Urbicus Ref: URB25-281
Primary Contact: Max Clayton

Applicant response to an information request under Section 13 of the Development Assessment Rules

Council reference: A006899145
Property details: 15 Ullswater Street, Virginia QLD 4014

Figure 1 Amended Site Plan

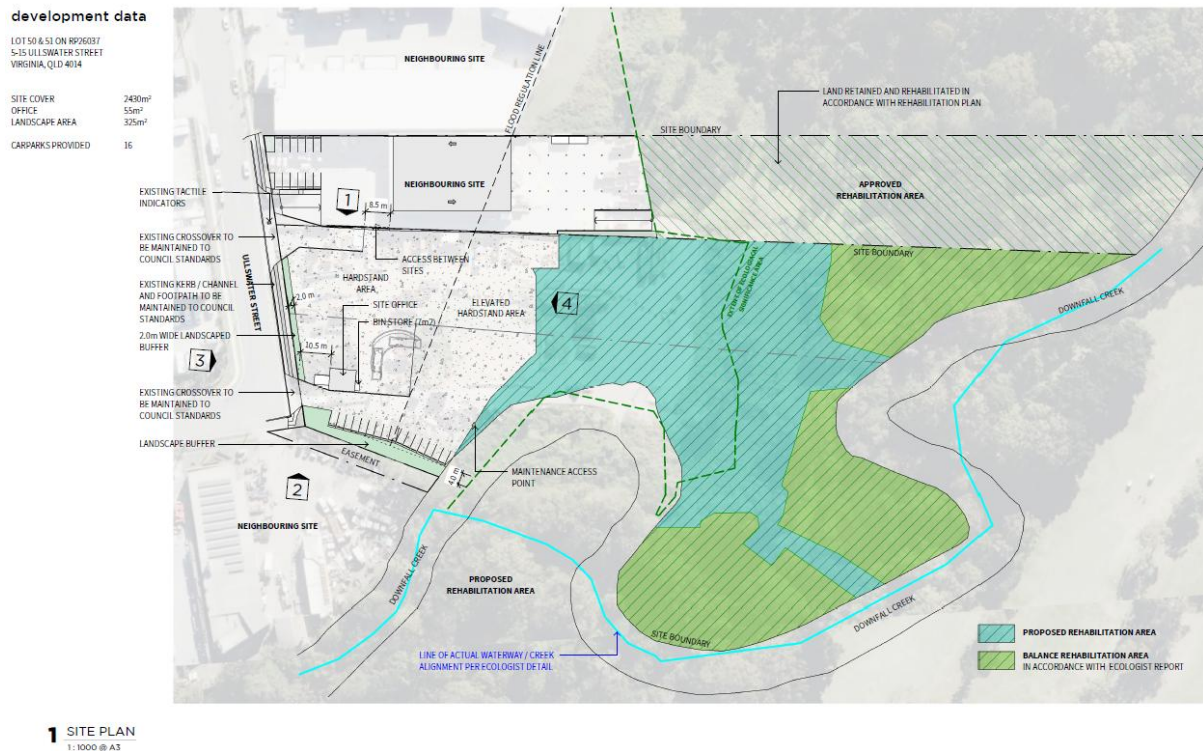
Item	Access Ramp
2	<p><i>The proposal plans show an access ramp on Lot 49 which is noted as for maintenance access. It is understood the original approval over Lot 49 included a ramp to the rear of the site in order to provide maintenance access to the rear of the site and undercroft area. However the extension of the ramp as shown (and which is shown to be existing on aerial mapping) is not supported as it extends within the area previously designated to be drainage reserve dedicated to Council, which was also to be rehabilitated.</i></p> <p><i>a. Provide amended plans which remove the rear access ramp extending into the protected area from the proposal and return the ramp to the extent and form previously approved over Lot 49 under A002385903 and it is not to be used for maintenance access to Lots 50 and 51.</i></p>

Item	Car Parking
3	The proposed car parking spaces should ideally be located near the proposed site office to avoid lengthy pedestrian routes to the office, through the operational areas of the site. The car parking spaces are measured as being more than 45 metres from the site office.
Item	Refuse Storage and Collection
4	Demonstrate the location and size of the proposed refuse storage area to service the site. The refuse storage area is to be in a position which is accessible to service vehicles on the site and enable onsite refuse collection. Note: the refuse storage area needs to be housed either within a building or within a roofed and wholly screened enclosure.

Response: Refer to **Appendix A** and **Figure 1**. The access ramp currently extending into the rehabilitation area within the rear portion of the adjoining site to the north (15 Ullswater Street) has been removed.

Response: Refer to **Appendix A** and **Figure 1**, which shows the following amendments to

- The Site office relocated further south within the Site boundary, immediately north of the existing access crossover and car parking areas over 5 Ullswater Street; and
- Screened and roofed bin store immediately east of the proposed office.
